STATE OF NORTH CAROLINA
DEPARTMENT OF TRANSPORTATION

Subject: **Revised Application for a Section 404 Individual Permit, Section 401 Water Quality Certification, and Neuse Riparian Buffer Authorization** for construction of the widening of NC 42 from US 70 (Clayton) to east of SR 1902 (Rocky Branch Rd) in Johnston County. Federal Aid Project No. STP-42(4). State Project No. 8.1312301. TIP No. R-3825A.

Please find revised permit drawings and roadway plans showing the reduction in wetland impacts from the previously submitted drawings. In addition, a revised Debit Ledger for the Marks Creek Mitigation Site reflecting the wetland impact reduction is also included.

8

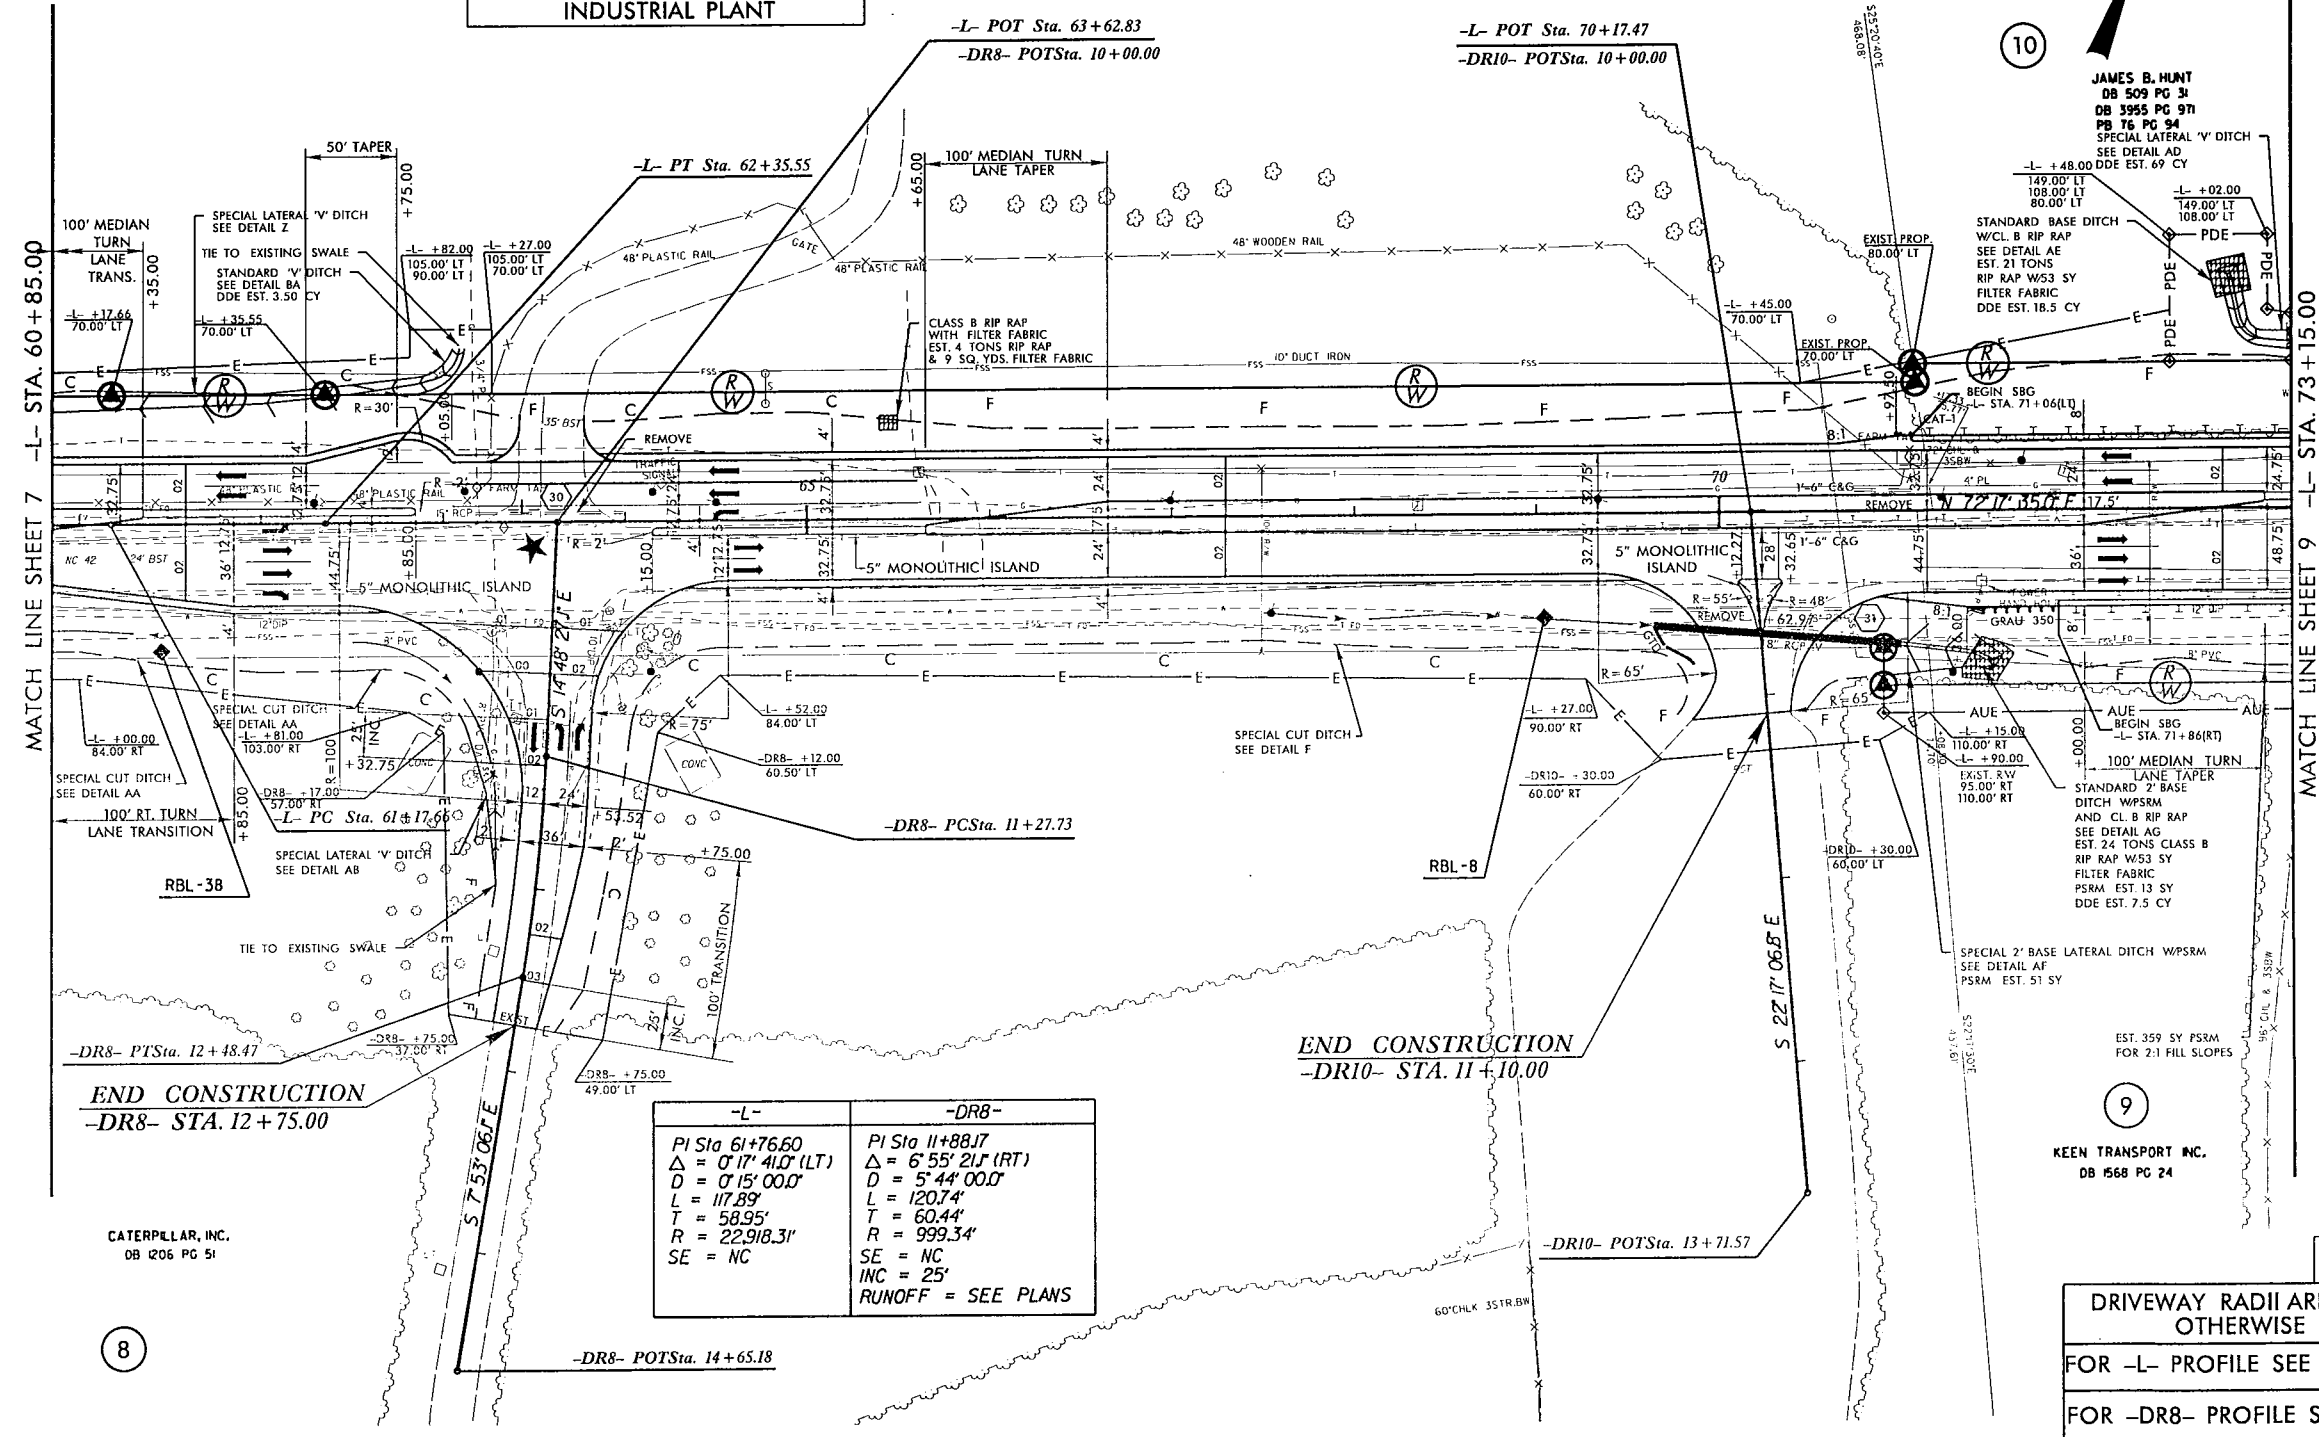
- (Sheet 7) -Revising Temporary Construction Easement to Permanent Drainage Easement around ditch on Parcel No. 8.
- (Sheet 8) -Revising Temporary Drainage Easement to Permanent Drainage Easement around ditch on Parcel No. 10.
-Modifying Temporary Construction Easement on Parcel No. 9.
- (Sheet 9) -Adding Permanent Drainage Easement around pipe outlet on Parcel No. 9.
-Removing a property line and eliminating Parcel No. 15.
-Revising Parcel No. 10 to Parcel No. 10A from station 76+78.74 to station 80+14.22.
-Modifying Temporary Construction Easement on Parcel No. 10A.

11/2/11 RW REVISIONS: REVISED TDE TO PDE ON PARCEL NO. 10. MODIFIED TCE ON PARCEL NO. 9 DDK

9

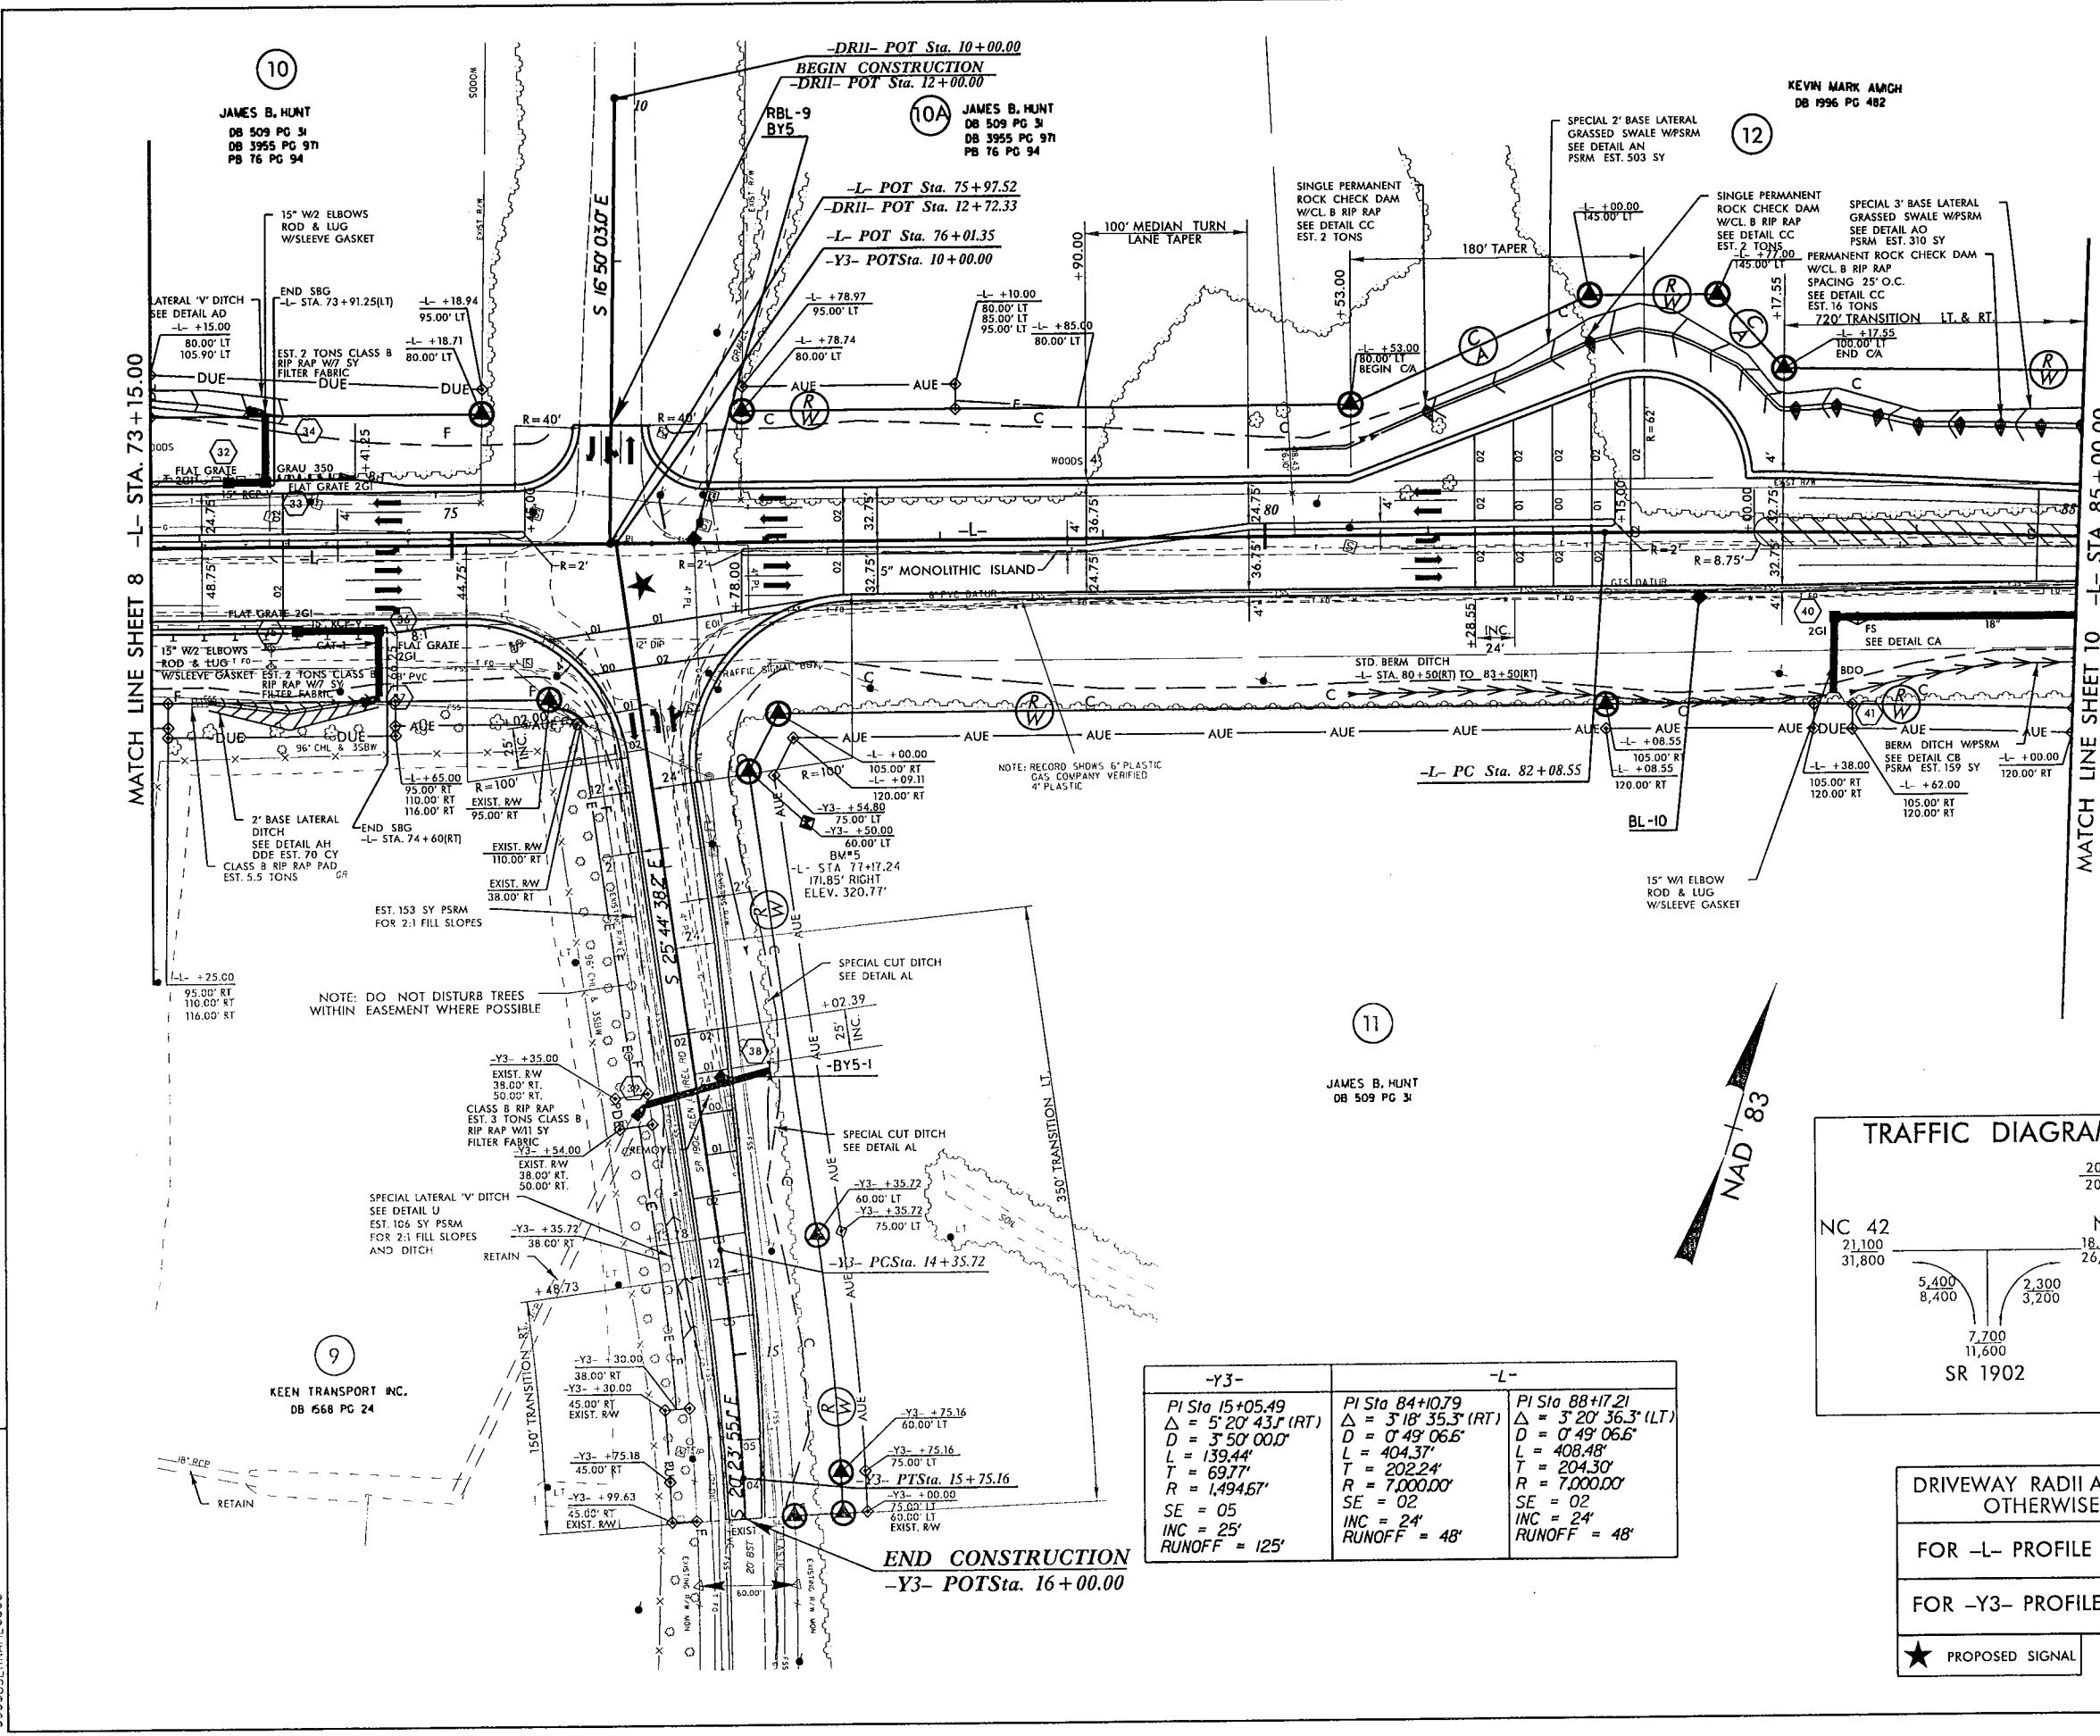
REVISIONS
 11/21/11 RW REVISIONS: ADDED PDE ON PARCEL NO. 9; REVISED PARCEL NO. 10 TO PARCEL NO. 10A FROM STATION 76+78.74 TO 80+14.22; MODIFIED TCE ON PARCEL NO. 10A; REMOVED PROPERTY LINE AND EUMINTED PARCEL NO. 15, DDK
